Service Letter #: SL06-36-70008

Part/Assembly #: 36-70008/Supplemental Airplane Flight Manual (SAFM) A-10011 – all previous.

Float Model Affected: Aerocet Model 3500 and 3500L on Cessna 206 Aircraft (STC SA00003SE) (All before 8/1/13)

Figure 1 Showing correct verbiage from SAFM

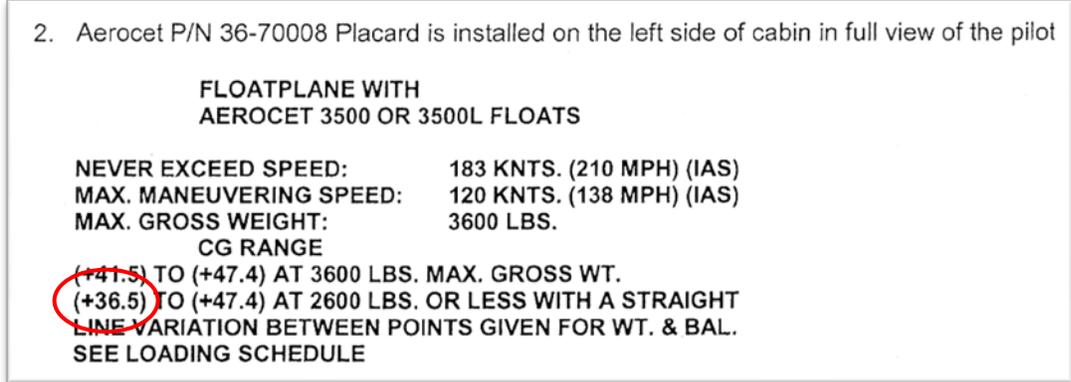
Symptom: Typographical Error on Aerocet supplied placard: light, forward CG may be incorrect. Flight Manual Supplement A-10011 has correct limitations.

Corrective Action: Please check your installation against the SAFM. Replacement placards are available through Aerocet or you can correct your existing placard by any permanent means.
